**Consent Notice Pursuant to Section 221  
Resource Management Act 1991**

File Ref: S/B 8508

**Lynley Park Subdivision, Omokoroa  
Lot 123 Geotechnical Completion Report**

### **Lynley Park - Earthworks Completion Report**

Figure 3

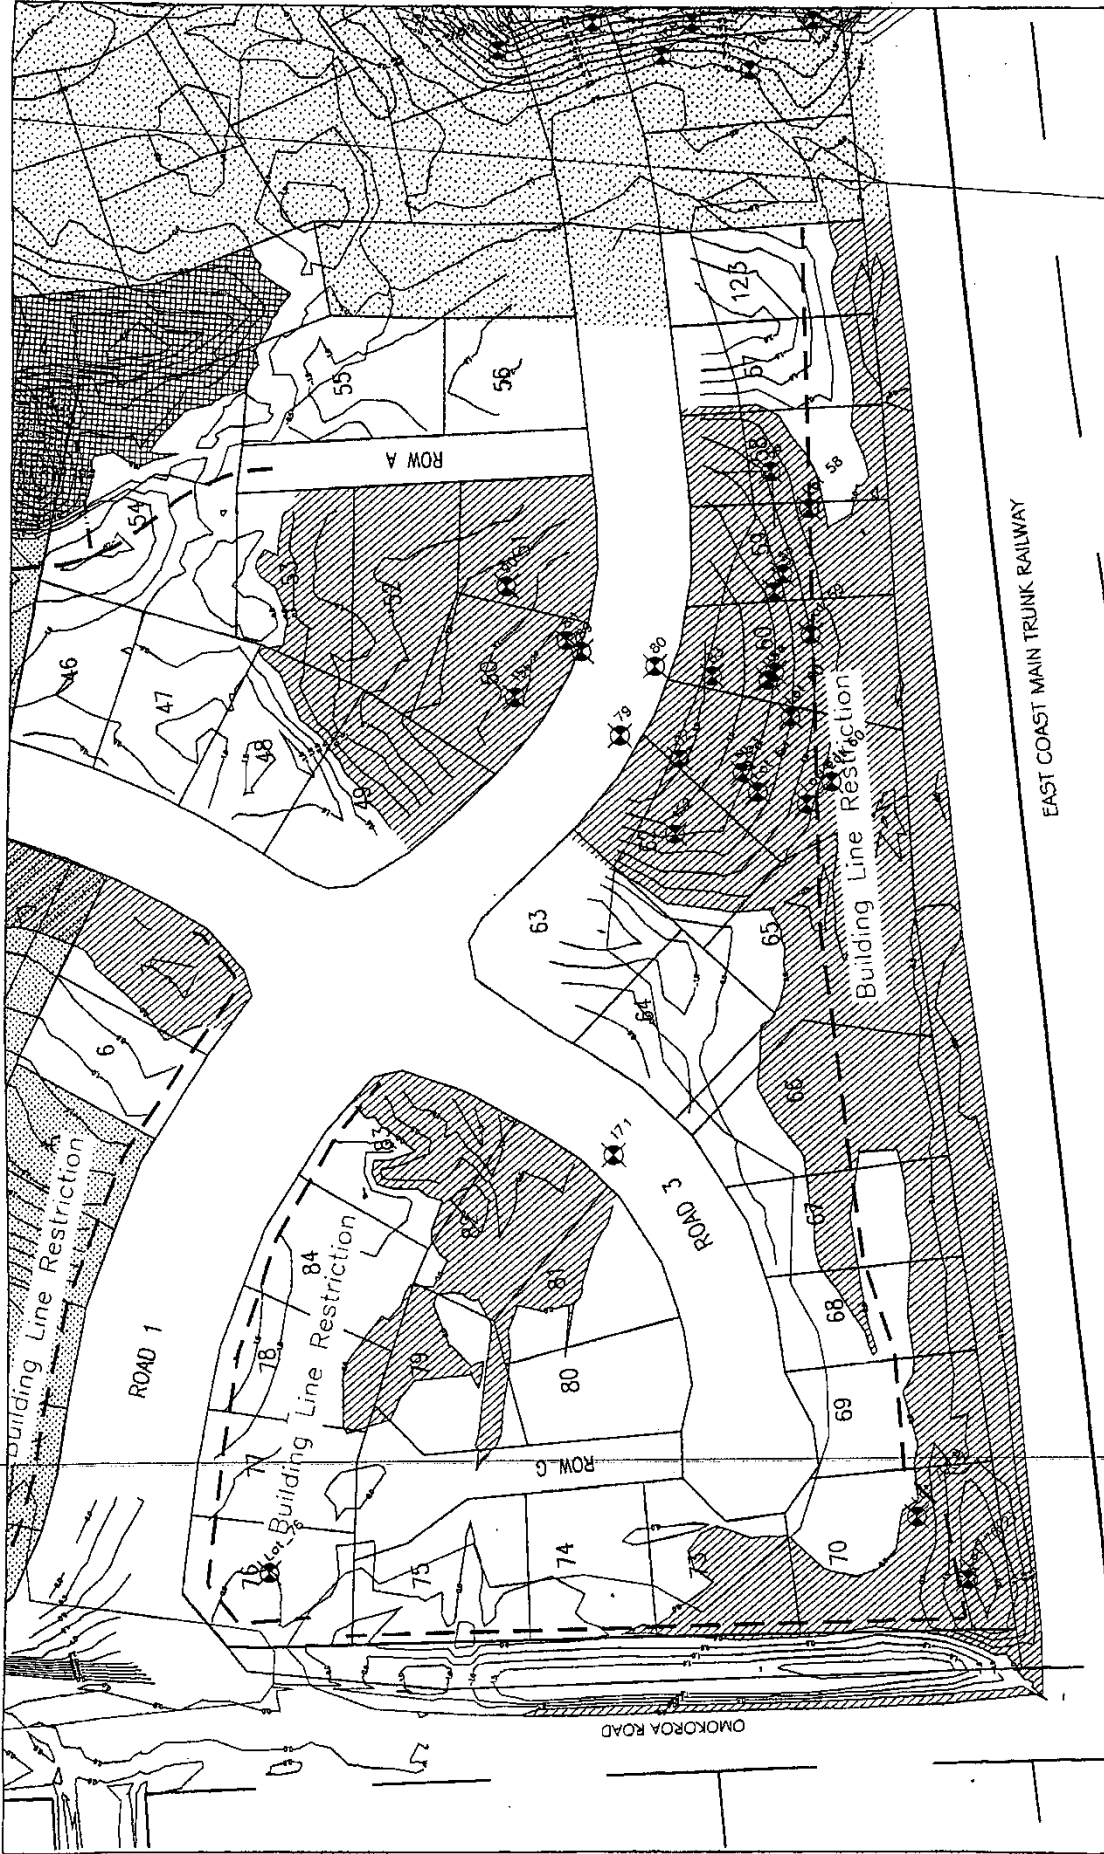
- Summary Lot table for Lot 123
- Site test location plan Figure 3 rev1 showing lot location and cut/fill depths
- Statement of Professional Opinion for Lot 123
- Section 224 Certification Statement

- b) The completed works give due regard to land slope and foundation stability considerations.
  - c) The earth fills shown on the attached plan (T&T Figure 3, rev 1), have been placed in accordance with the Subdivision and Development Code of Practice of the Western Bay of Plenty District Council.

### Lynley Park Development SUBSOIL DRAINAGE

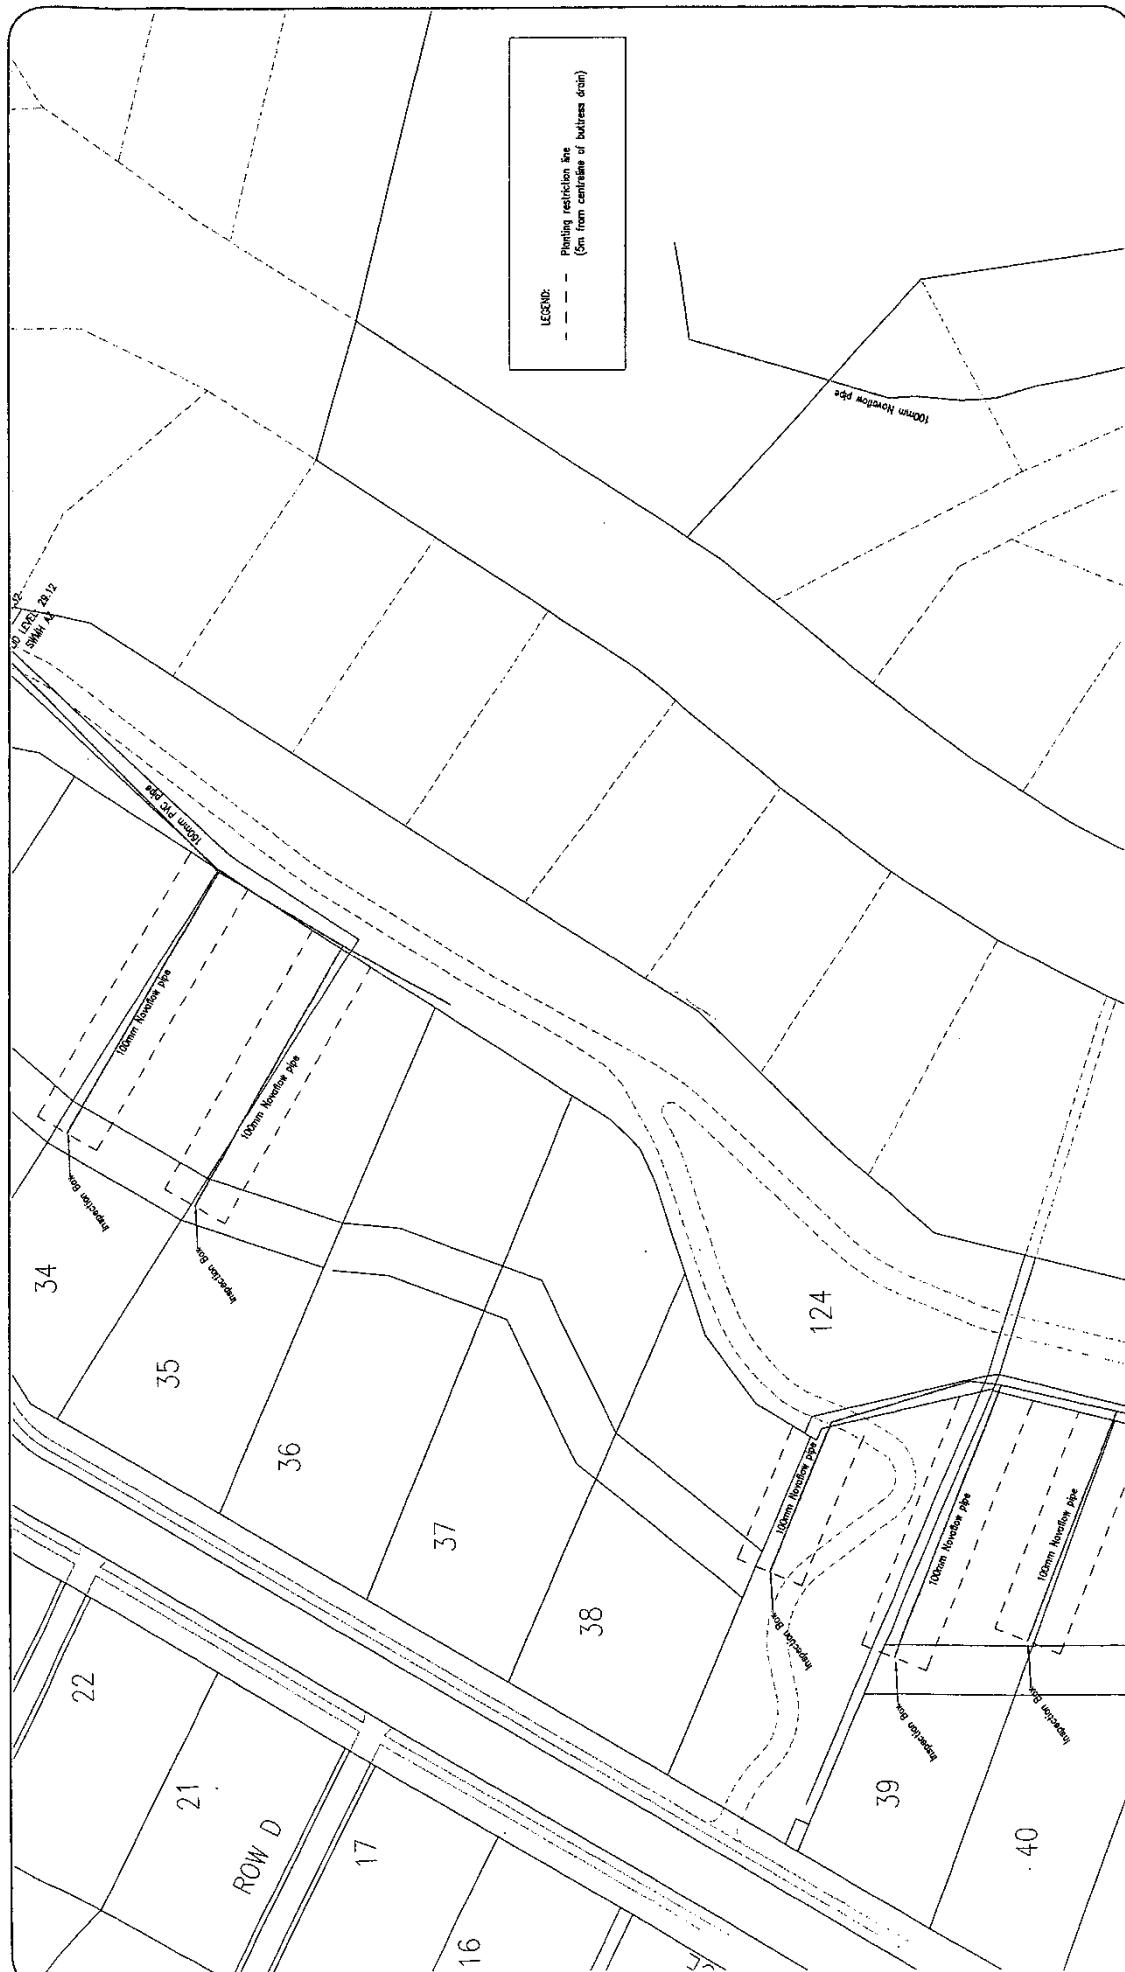
A15.7 *THAT no trees be planted within a horizontal distance of 5.0 metres from the centre line of the buttress drains as shown on the attached CKL drawing Subsoil Drainage (Ref D1176 Rev AB1) Pages 2 -5, unless prior written approval from the Western Bay of Plenty District Council is obtained. Trees will only be permitted which have a shallow root structure so as to avoid any detrimental affect on the Buttress Drains. The landscaping measures as required by conditions A4.3 of consent are to be maintained at all times.*

Issue	Description	Date
AB	AS-BUILT	03/2006
AB1	Added planting restriction line	04/2006
Designed	Checked	Date
Drawn

Planting restriction line  
(5m from centreline of business drive)
